# Access Compliance Report

## Public Rights-of-Way

### (Curb Ramps)

Intersection ID: 50613	Main Street: BALSAM_BAY_RD	Cross Street: DOWNY_BIRCH_RD	Location: S
ADA ID: 9770DE52D1BA	Ramp Type: Perp	Initial Pass/Fail: Fail	Overall Compliance: No
Severity Score: 22.5			
Codes/Mitigation Info/Possible Solution		Field Measurements/Component Compliance

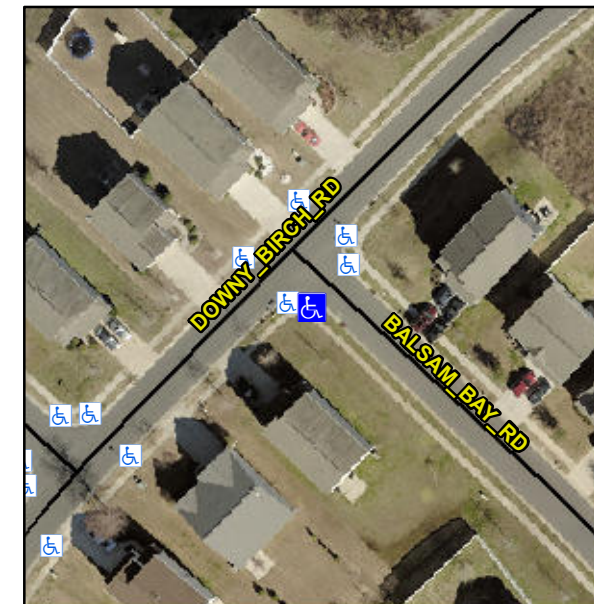
**Not Found, R304.5.1, R304.2.2, R304.5.3**

Compliance	Description	Data	Compliance	Description	Data
N/A	Ramp Length (in)	46.0	No	Ramp Slope (%)	8.4
No	Ramp Width (in)	42.0	No	Ramp XSlope (%)	2.2
N/A	Flare Type LT	N/A	N/A	Flare Type RT	N/A
N/A	Flare Slope LT (%)	N/A	N/A	Flare Slope RT (%)	N/A
N/A	Flare Traversable LT?	N/A	N/A	Flare Traversable RT?	N/A
N/A	Landing Length (in)	N/A	N/A	DWS Provided?	N/A
N/A	Landing Width (in)	N/A	N/A	DWS Contrast?	N/A
N/A	Landing Slope (%)	N/A	N/A	DWS Length (in)	N/A
N/A	Landing X Slope (%)	N/A	N/A	DWS Full Width?	N/A
N/A	Landing Curb? (Y/N)	N/A	N/A	DWS Offset (in)	N/A
N/A	Shared Landing?	N/A			
N/A	Gutter Ponding?	N/A	N/A	Gutter Slope (%)	N/A
N/A	Gutter Lip Ht (in)	N/A	N/A	Gutter X Slope (%)	N/A
N/A	Painted X Walk1?	No	N/A	Painted X Walk2?	N/A
	X Walk 1 Direction	To SE		X Walk 2 Direction	N/A
N/A	X Walk 1 Width (in)	N/A	N/A	X Walk 2 Width (in)	N/A
	X Walk 1 Slope (%)	3.3		X Walk 2 Slope (%)	N/A
	X Walk 1 X Slope (%)	0.4		X Walk 2 X Slope (%)	N/A

**Remove & Replace Entire Ramp.**
